**US Magnesium LLC**

Re: Requested Revisions to US Magnesium's "Mine and Reclamation Plan" of Oct. 2008

**MINE AND RECLAMATION PLAN**  
**STANSBURY BASIN / ROWLEY PROJECT**

**Proposed Response to UDOGM April 17, 2009 Comments on USM Mine & Reclamation Plan**

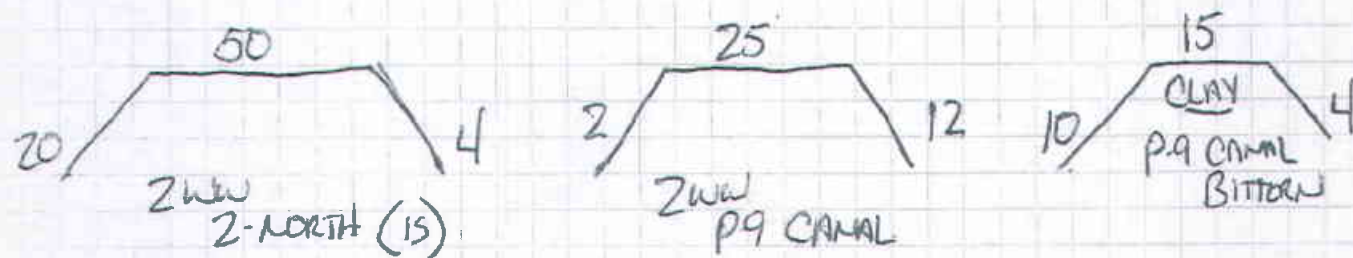
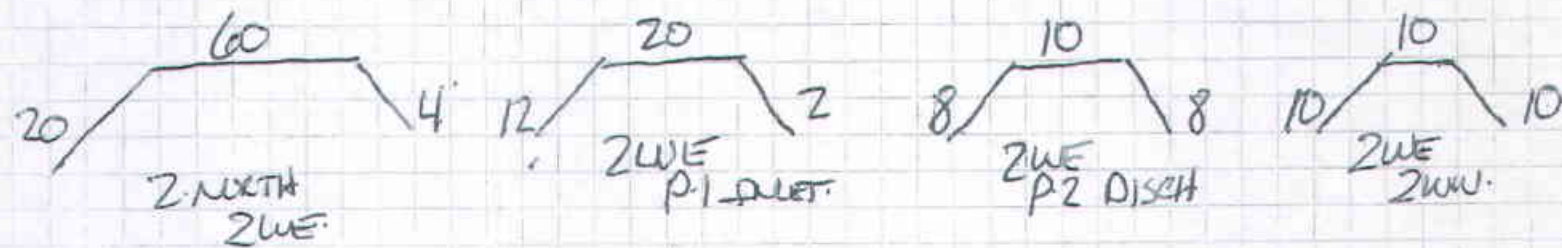
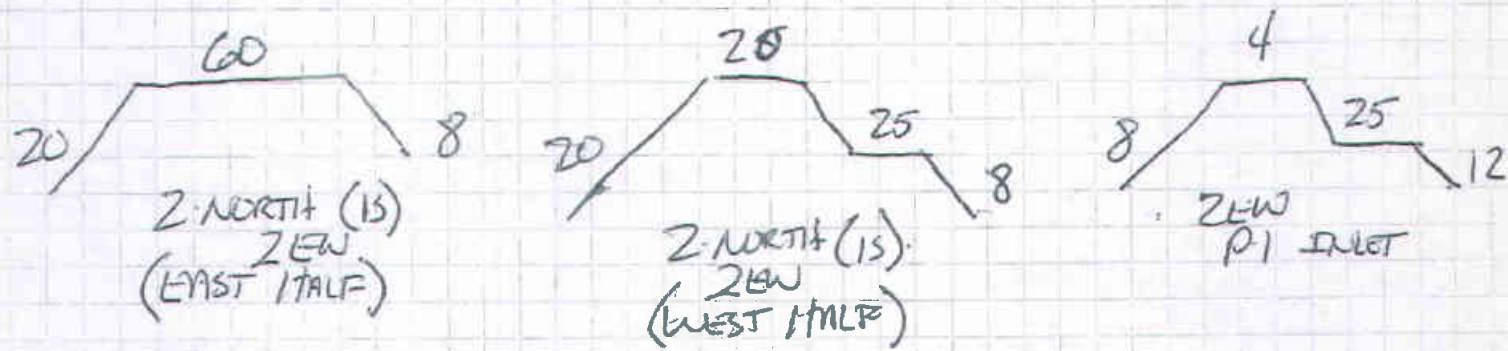
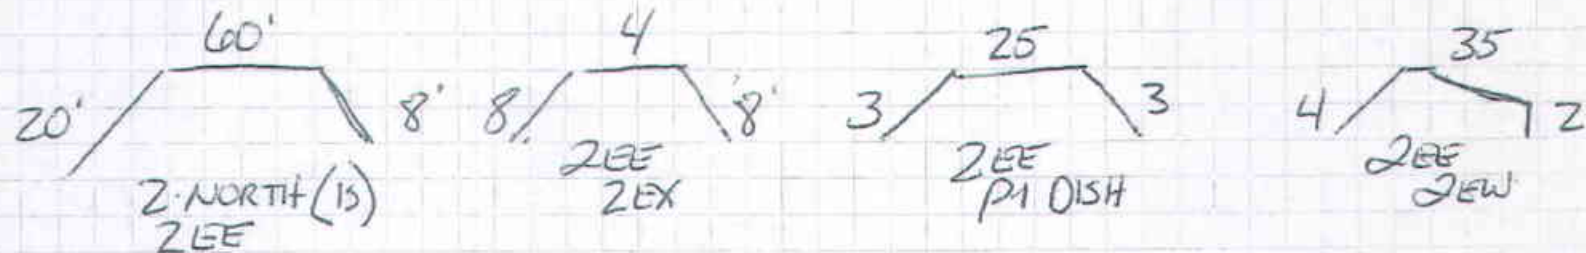
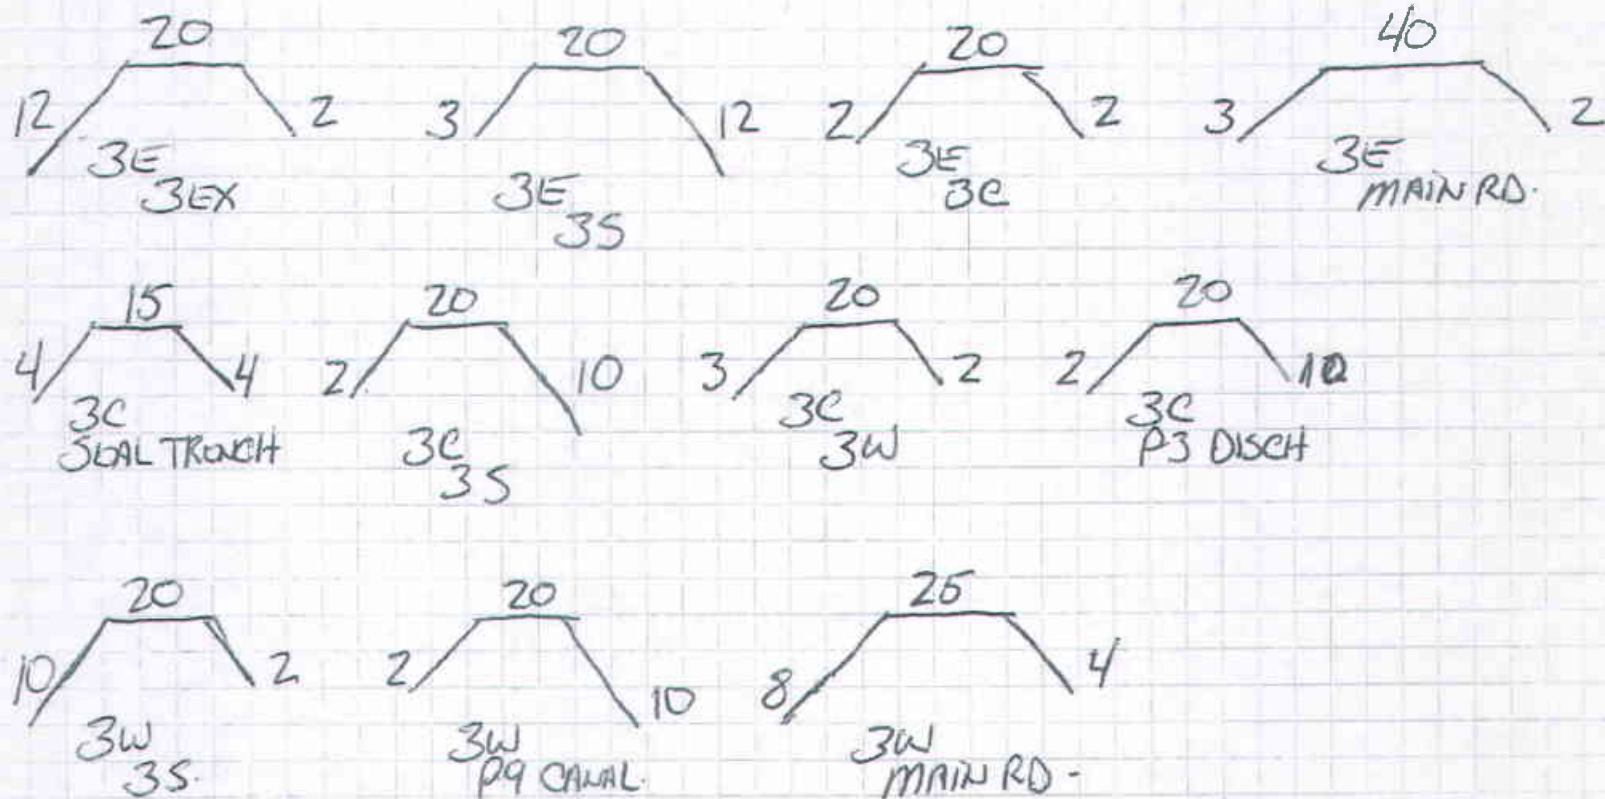
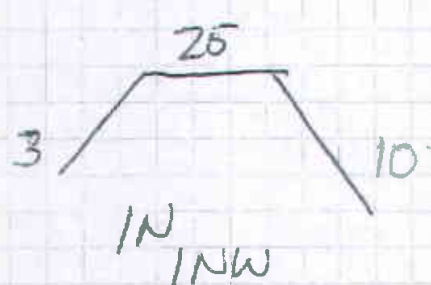
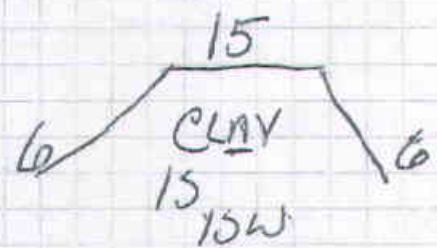
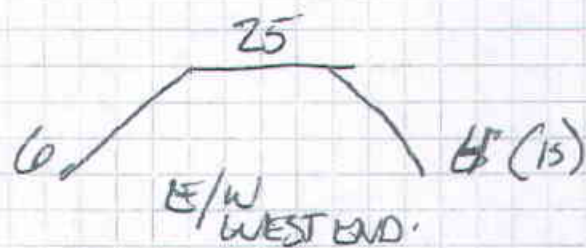
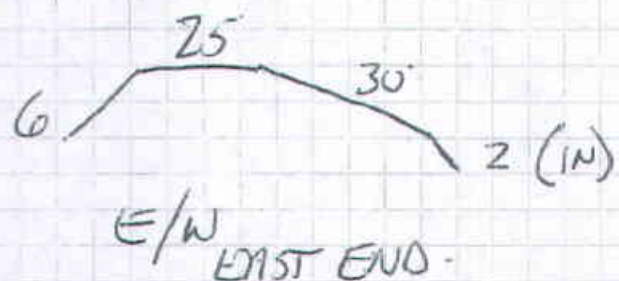
12	Omission	"Cross section of roads or other earthen structures" as per 105.3.12. This would include cross sections of the dikes.	This information will be provided
13	Omission	"water impounding structures ... greater than 20 acres" as per 105.1.13	Water impounding structures covered under R647 rules are already shown and comprise the "mine." Requirement R647-4-105.1.13 seems to note access from public roads. [New numbering R647-4-105 3.13]
14	Omission	"area which will be disturbed but not reclaimed" as per 105.3.14	US Magnesium would like to have a further discussion to clarify what is disturbed and what "not reclaimed" means in the context of 75,000 acres of salt covered solar ponds.
15	Omission	"actual solar ponds are shown, and defined on figure 4.2 and 4.3, but other hydrology structures are not defined for the rest of the operation.	See response to UDOGM comment #6. The other hydrologic features are not on the "mine site" and are covered by other rights of way governed by other agencies.

- A redline version of a revised plan as requested.
- A spread sheet tracking Utah Division of Oil, Gas and Mining's comments on the submitted plan and US Magnesium's thoughts/responses
- A revised Figure 4.4 (Comment 29)
- A copy of the SPCC plan properly signed by a professional engineer (Comment 30)
- A diagram showing cross sectional dimensions of solar pond dikes (Comment 12)

MAJORITY OF DIKES ARE 2-1 SLOPE -

DIKES ARE 2-1 SLOPE.
